Access Compliance Report

Public Rights-of-Way

(Curb Ramps)

Intersection ID: 9211	Main Street: E_SUGAR_CREEK_RD	Cross Street: GREENSBORO_ST	Location: NW
ADA ID: 88B0D93682E6	Ramp Type: Perp	Initial Pass/Fail: Pass	Overall Compliance: No
Severity Score: 2.5			
Codes/Mitigation Info/Possible Solution		Field Measurements/Component Compliance

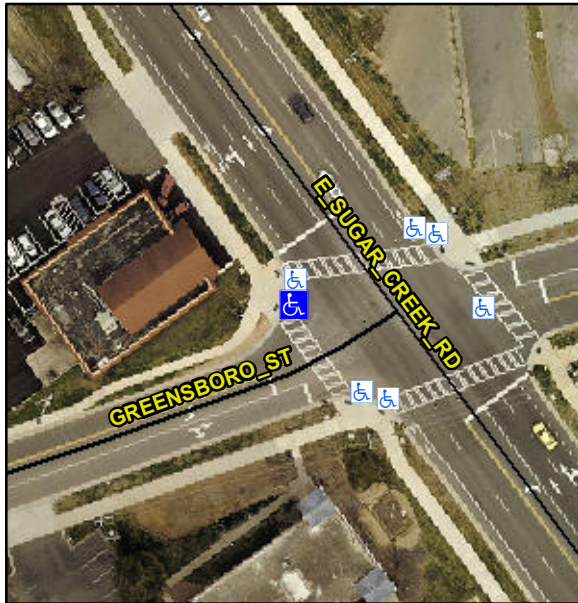
Not Found, R305.1.4, R305.2

Compliance	Description	Data	Compliance	Description	Data
N/A	Ramp Length (in)	120.0	Yes	Ramp Slope (%)	5.8
Yes	Ramp Width (in)	52.0	Yes	Ramp XSlope (%)	1.2
N/A	Flare Type LT	Sloped	N/A	Flare Type RT	N/A
N/A	Flare Slope LT (%)	4.9	Yes	Flare Slope RT (%)	9.8
N/A	Flare Traversable LT?	No	N/A	Flare Traversable RT?	Yes
Yes	Landing Length (in)	72.0	Yes	DWS Provided?	Yes
Yes	Landing Width (in)	49.0	Yes	DWS Contrast?	Yes
Yes	Landing Slope (%)	0.5	Yes	DWS Length (in)	24.0
Yes	Landing X Slope (%)	1.7	No	DWS Full Width?	No
N/A	Landing Curb? (Y/N)	No	No	DWS Offset (in)	3.5
N/A	Shared Landing?	No			
Yes	Gutter Ponding?	No	Yes	Gutter Slope (%)	2.9
Yes	Gutter Lip Ht (in)	0.0	Yes	Gutter X Slope (%)	2.3
N/A	Painted X Walk1?	Yes	N/A	Painted X Walk2?	N/A
	X Walk 1 Direction	To S		X Walk 2 Direction	N/A
N/A	X Walk 1 Width (in)	103.5	N/A	X Walk 2 Width (in)	N/A
	X Walk 1 Slope (%)	4.3		X Walk 2 Slope (%)	N/A
	X Walk 1 X Slope (%)	3.4		X Walk 2 X Slope (%)	N/A

Yes	Ramp inside XWalk1?	Yes	N/A	Ramp inside XWalk2?	N/A
	Road Slope (%)	N/A	N/A	Clear Space?	Yes
	Road X Slope (%)	N/A	N/A	Clear Space to XWalk (in)	N/A
Yes	Any Obstructions?	No	Yes	Storm Grate/Utility Hazard?	No
	Obstruction Type			Storm Grate/Utility Type	
		N/A			N/A
			Yes	Surface Condition? (G/P)	Good

Remove & Replace Entire Ramp.
